April 3, 2003  
Contract No. NRC-02-02-012  
Account No. 20.06002.01.081

Subject: Submittal of Intermediate Milestone—Assessment of Mechanisms for Early Waste Package Failures, IM 06002.01.081.310

# **ASSESSMENT OF MECHANISMS FOR EARLY WASTE PACKAGE FAILURES**

**Figure 4-3. Effect of Weld Thickness on Flaw Density Normalized to a Thickness of 25.4 mm [1 in] (CRWMS M&O, 2000a).**

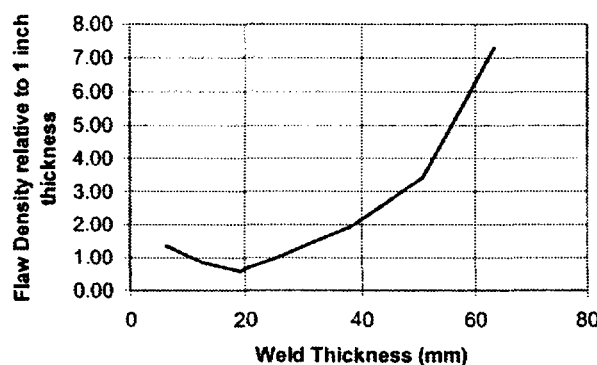
- Published stainless steel data using the RR-PRODIGAL code are bounding for predicting features of flaws in the welds for Alloy 22. DOE assumed the simulation results obtained by Khaleel, et al. (1999) are bounding and the results provided by the RR-PRODIGAL code are conservative by a factor as large as 10 (Simonen and Chapman, 1999). Simonen and Chapman (1999) based their analysis on the measurement of weld flaws greater than 4 mm [0.16 in] depth in pipes and vessels installed in U.S. nuclear power plants and showed that the RR-PRODIGAL code simulations are conservative compared with observed weld flaw frequencies in reactor pressure vessels. However, they completely ignored observed small flaws as reported by Chapman, et al. (1996), Chapman and Simonen (1998), Doctor, et al. (1999), and Schuster, et al., (2000, 1999, and 1998). Validation data showed that for the simulation to match the experimental data, small cracks less than 3 mm [0.12 in] in size have to be ignored. Therefore, the DOE assumption results in a nonconservative flaw frequency distribution of one to two orders of magnitude. The DOE use of simulation results with no verification is inappropriate for estimating the flaw size distribution in Alloy 22.

- Weld flaw density and depth distributions for tungsten-inert-gas welded stainless steel can be applied to tungsten-inert-gas welded Alloy 22. Despite differences in the flow characteristics of Alloy 22 and stainless steel caused by the sluggish flow of Alloy 22, the DOE report assumed that welding of Alloy 22 is similar to the welding process of austenitic stainless steel. Even though DOE has welded Alloy 22, no systematic analysis has been conducted to show that the observed weld flaw frequencies are similar to austenitic stainless steel.
